HERSCHEL/PLANCK

REF.: H-P-ASP-MN-3513

COMpte Rendu de Reunion / MINUTES OF MEETING

SPIRE Progress & Interface Meeting & IIDB meeting

Mechanical IF Issues:

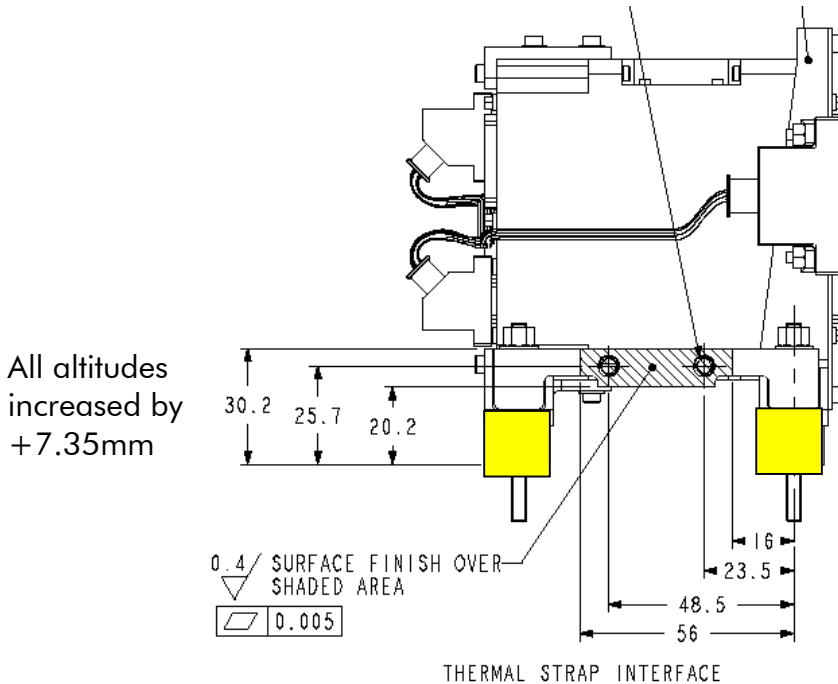
JFET Interfaces (Photometer & spectrometer). The thermal insulation of the JFET is not sufficient. The height of the carbon fibres support increase by 7.35 mm

Astrum will check if the change of altitude of the SPIRE JFET boxes can be taken into account (OBA, L3 interface position, and cryoharness (position of connectors)).

All changes have been taken into account in an update of the OBA end July for both JFET units.

In case the change can be implemented, SPIRE will issue a CR

Heschel Sorption cooler Straps expected heat flow profile & associated Temperature Requirement at Interface during Cooler recycling

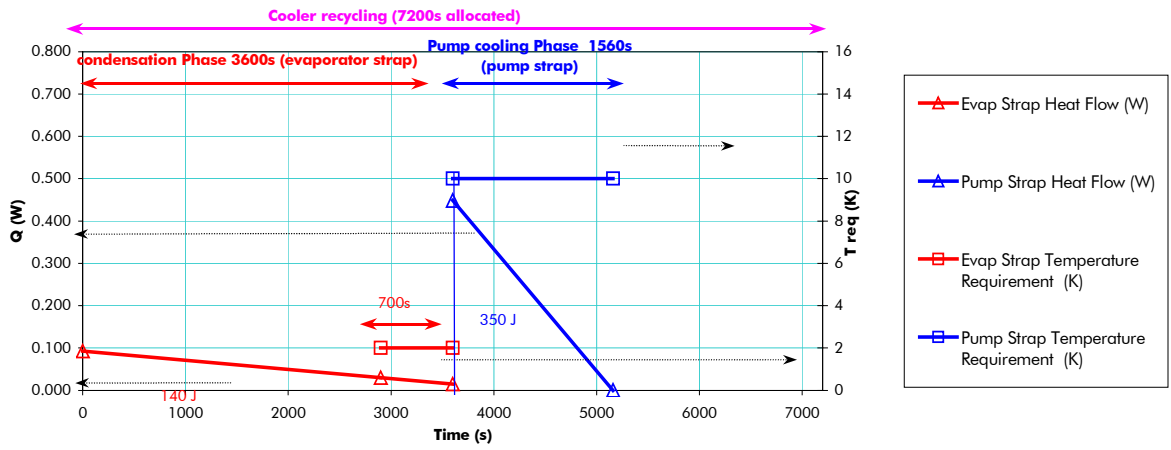
The 6K have still to be confirmed by SPIRE to be compatible with cooler recycling.

These environments are still under investigation, and it should be made clear that the cooler can be recycled.
